RESPONSE TO COUNCIL QUESTIONS RE: 8/16/2022 CITY COUNCIL AGENDA

Agenda Item #: 1

Title: Proposed Project: Related applications on a 1.25-acre site: DEVELOPMENT AGREEMENT (DA): Introduction of an Ordinance Approving and Adopting of a DA between the City of Sunnyvale and Gary Thon-Lon Hon and Nichole Ying Lin Hon, as trustees of the Hon Family Trust and Edward H. Leone Jr. LLC. SPECIAL DEVELOPMENT PERMIT (SDP): to demolish the existing buildings and construct a new 125,128 square foot four (4) story office building with two (2) levels of underground parking. Location: 480 and 490 S. Mathilda Avenue and 355 W. Olive Avenue (APNs: 209-28-008 and 052)

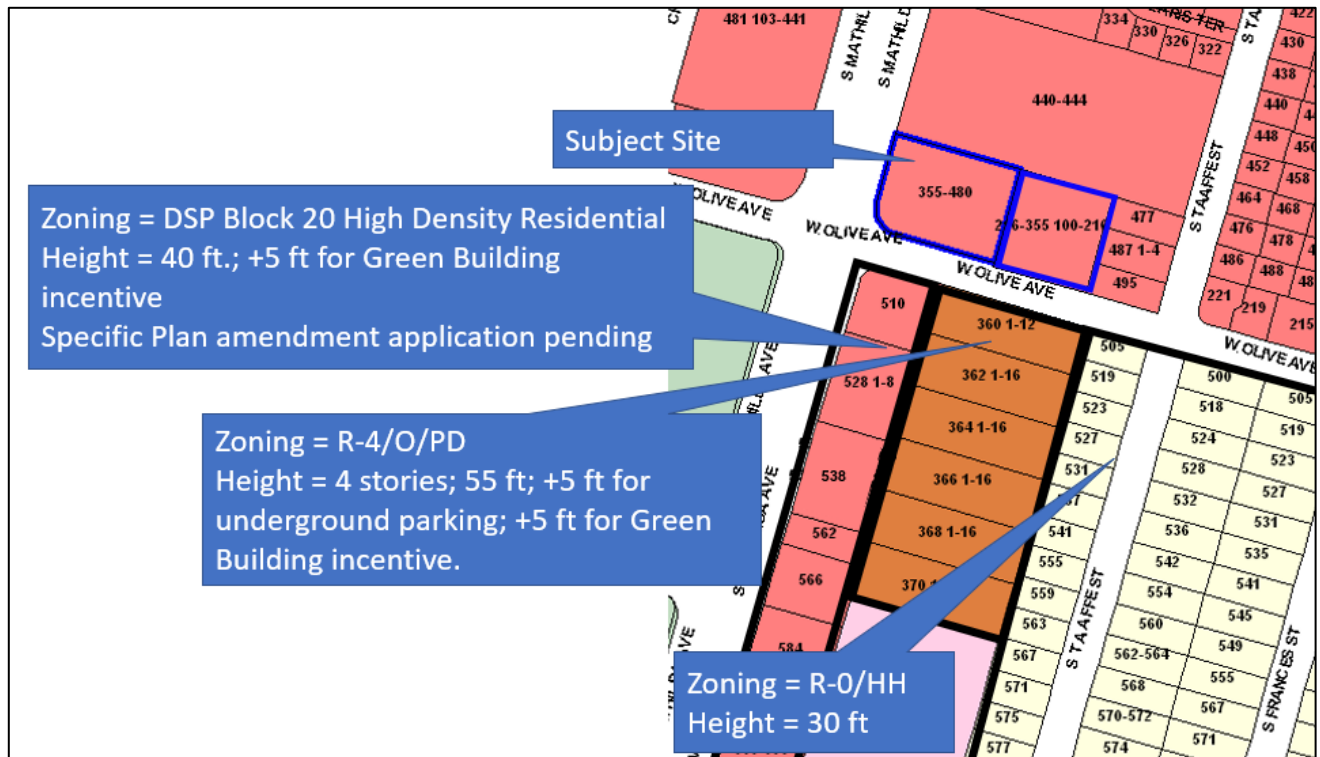
Council Question: What is the zoning of the properties across Olive from the proposed development? What is the maximum building height and maximum FAR for that zoning?

Staff Response: The annotated map below shows the zoning districts of properties on the south side of Olive Avenue

N/S BUILDING ELEVATIONS

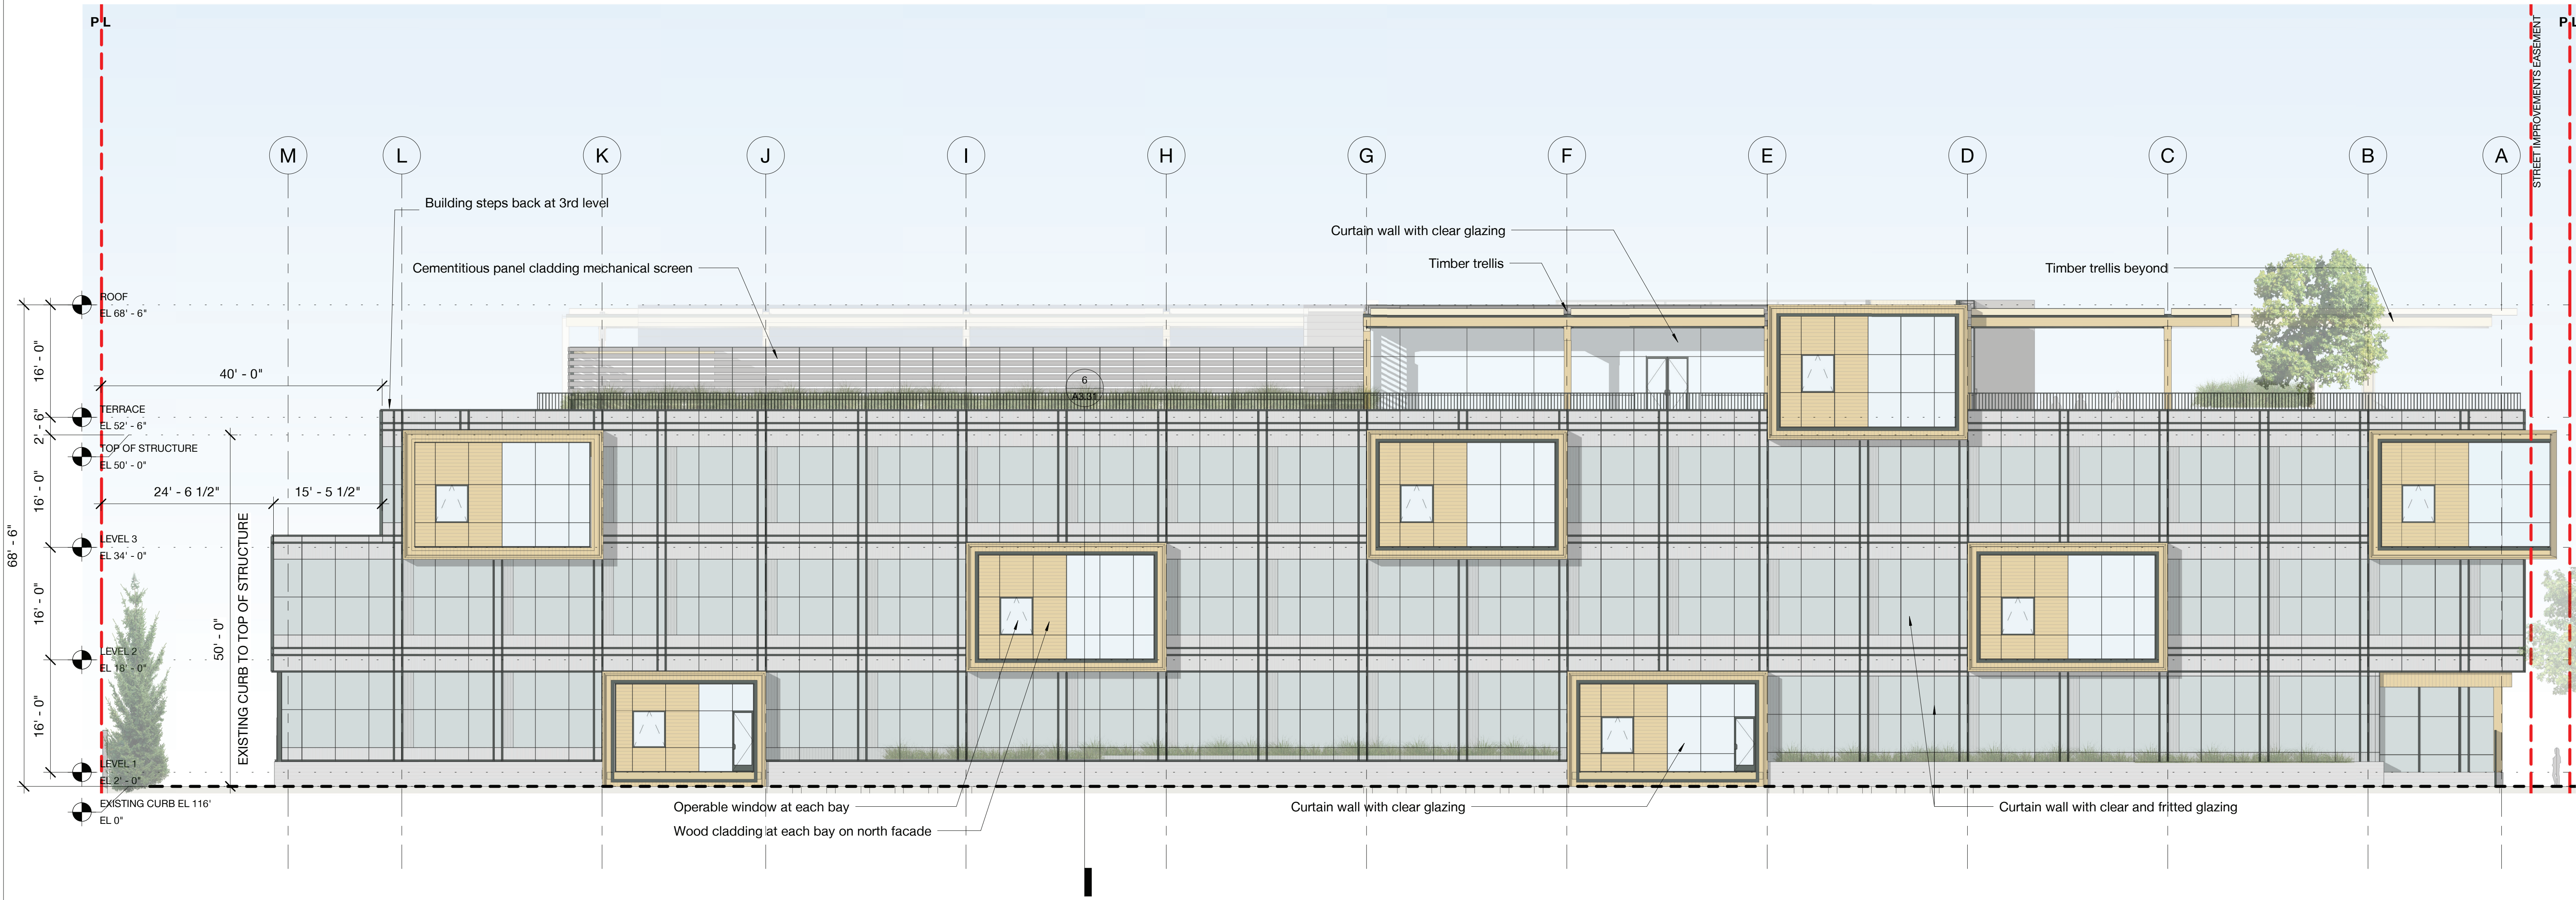
Council Question: The building elevations on sheets A3.01 and A3.02 of attachment 8 are incomplete. The right side of three of the elevations is blank, except for landscaping. Please provide complete elevations.

Staff Response: Complete elevations have been posted to Legistar (and are attached to this response). The paper copies should have complete pages.
